Mundijong Sales Yard

Building and incidental structures inspection report

June 2020

Structure D - Patio area adjoining Kitchen server

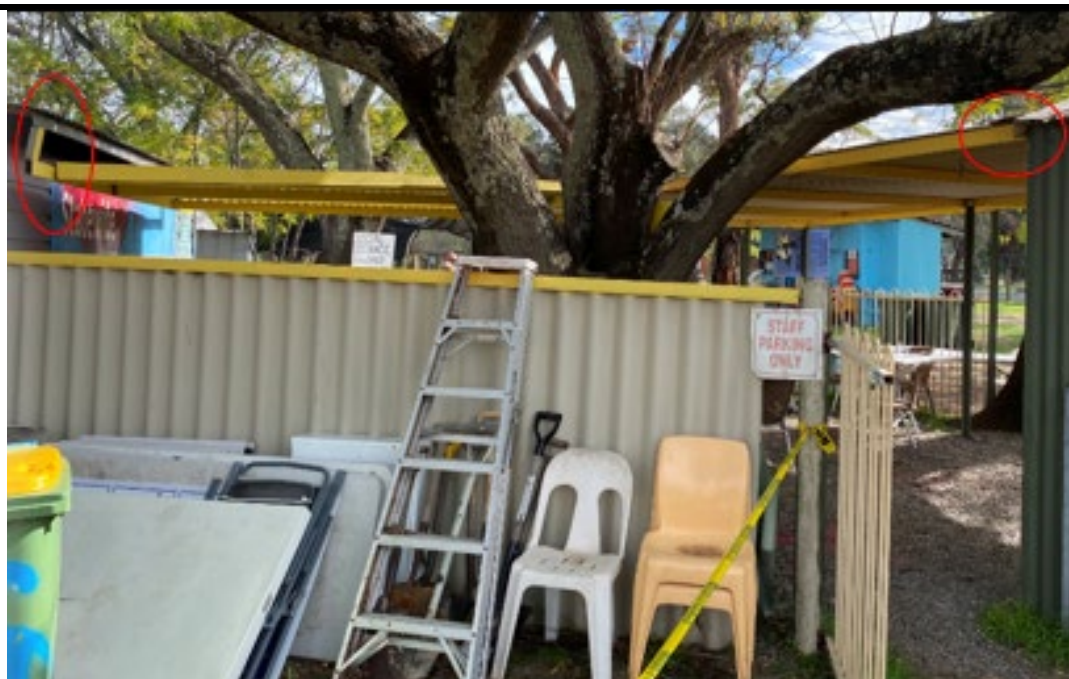
Description	A flat roof steel frame patio with sheet metal roof cladding and approx. 75mm x 38mm rectangular steel hollow patio tube posts. The flat roof patio is attached to the kitchen with server building (Structure C) and also attached to the rear of a stock yard Shed (structure E) by a cantilevered attachment
Condition	The structure appears to be in good condition although the steel tubing used as upright columns is generally used as roof beams or rafters with larger square hollow sections used as posts. Structural beams of structure E where patio is attached by Cantilevered attachment is exposed to weather and continue to deteriorate.

Cantilevered connection to building E

Patio conencted to two buildngs

Build date	unclear
Approval	None on record
Recommendation	Engage a suitably qualified structural engineer to inspect and certify the patio structure. Modifications may be required in order to certify the structural adequacy of the patio structure. Install roof guttering to capture storm water run-off and direct it away from the footings of any structures such as to a soak well.
